Request to Amend Order of Conditions

Under Wetlands Program Policy 85-4: Amended Orders

Proposed Self-Storage Facility

State Road
Whately, MA 01085
Assessor's Map 5 Parcel 29

NOTICE OF INTENT FILING PLAN

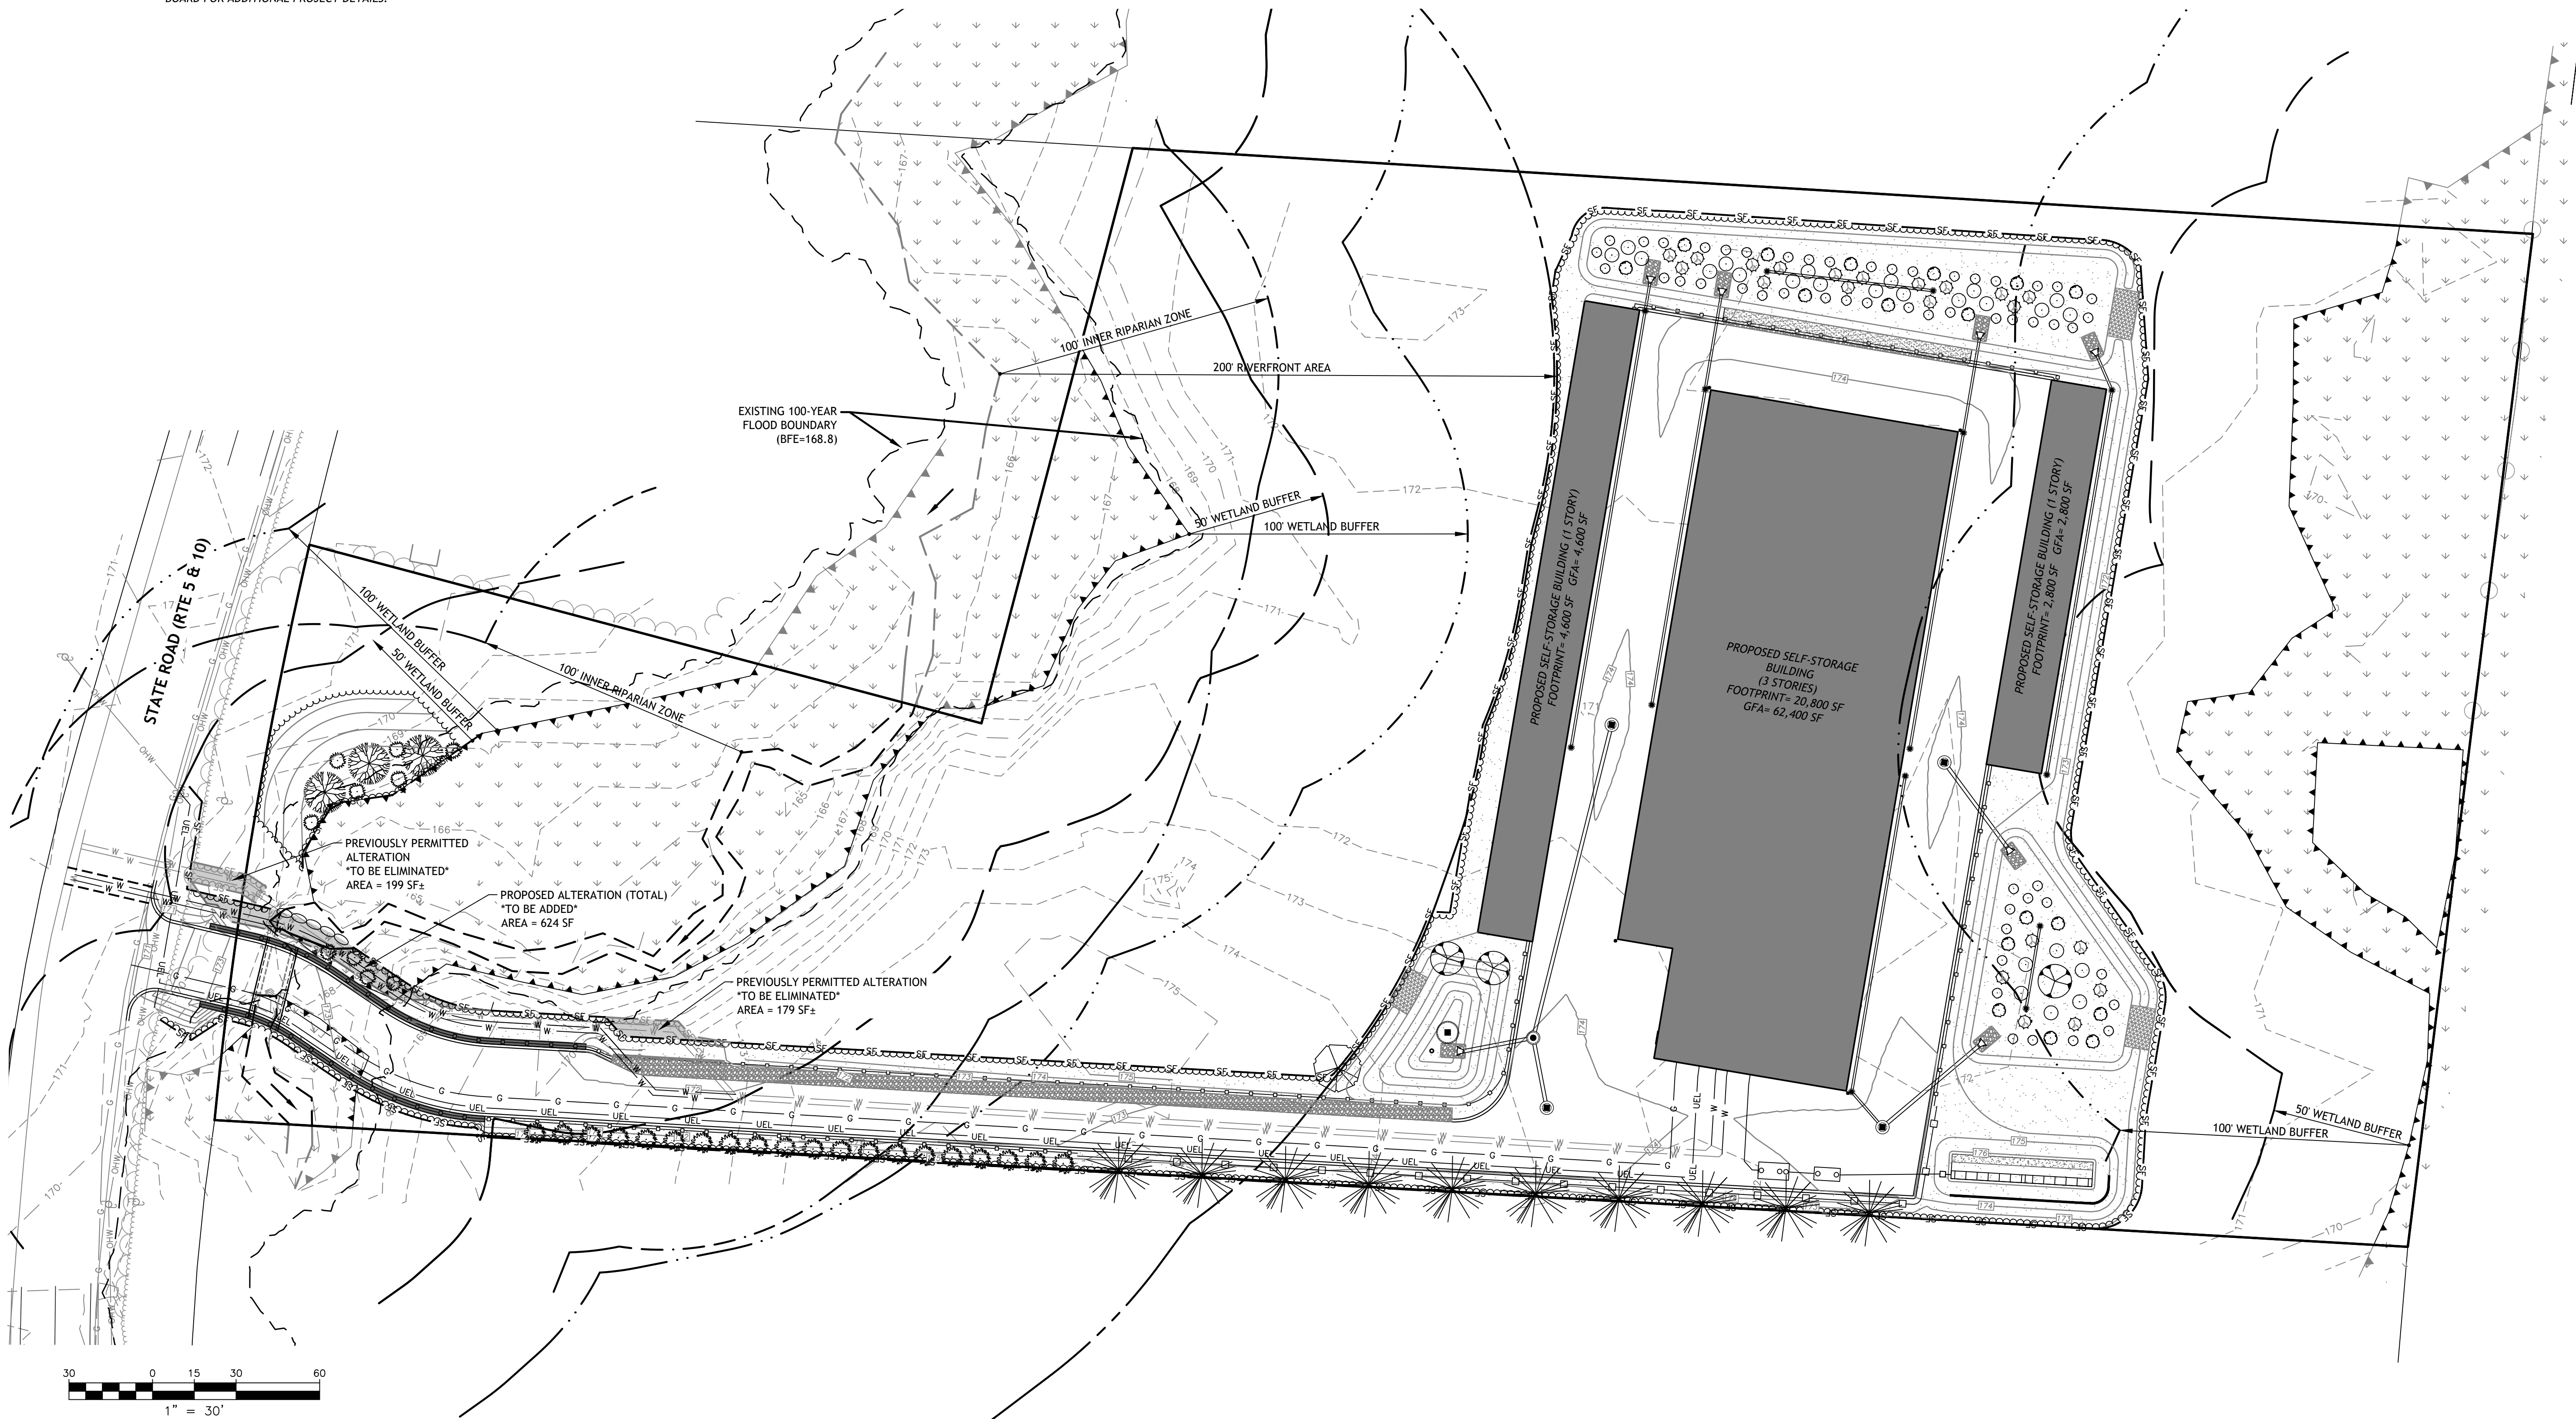
- THIS PLAN HAS BEEN CREATED TO AMEND THE AFOREMENTIONED EXISTING NOTICE OF INTENT AND FOR THE APPLICATION OF A NEW SUPPLEMENTAL NOTICE OF INTENT.
- THE APPLICANT PROPOSES TO AMEND THE EXISTING NOTICE OF INTENT BY REDUCING THE AREA OF ALTERATION, DETAILING THE STRUCTURAL REQUIREMENTS FOR THE PROPOSED CROSSING AND ADDING A DEWATERING PLAN.

- THE APPLICANT PROPOSES A NEW NOTICE OF INTENT IN ORDER TO ADD AN ADDITIONAL ALTERATION AREA AND ADD/IMPROVE EROSION CONTROL MEASURES FOR THE INSTALLATION OF TWO SUBSURFACE WATER LINES.

PROPOSED REDUCTION TO AREA OF ALTERATION	378 SF ±
PROPOSED ADDITION TO AREA OF ALTERATION	624 SF ±
NET CHANGE TO AREA OF ALTERATION	246 SF ±
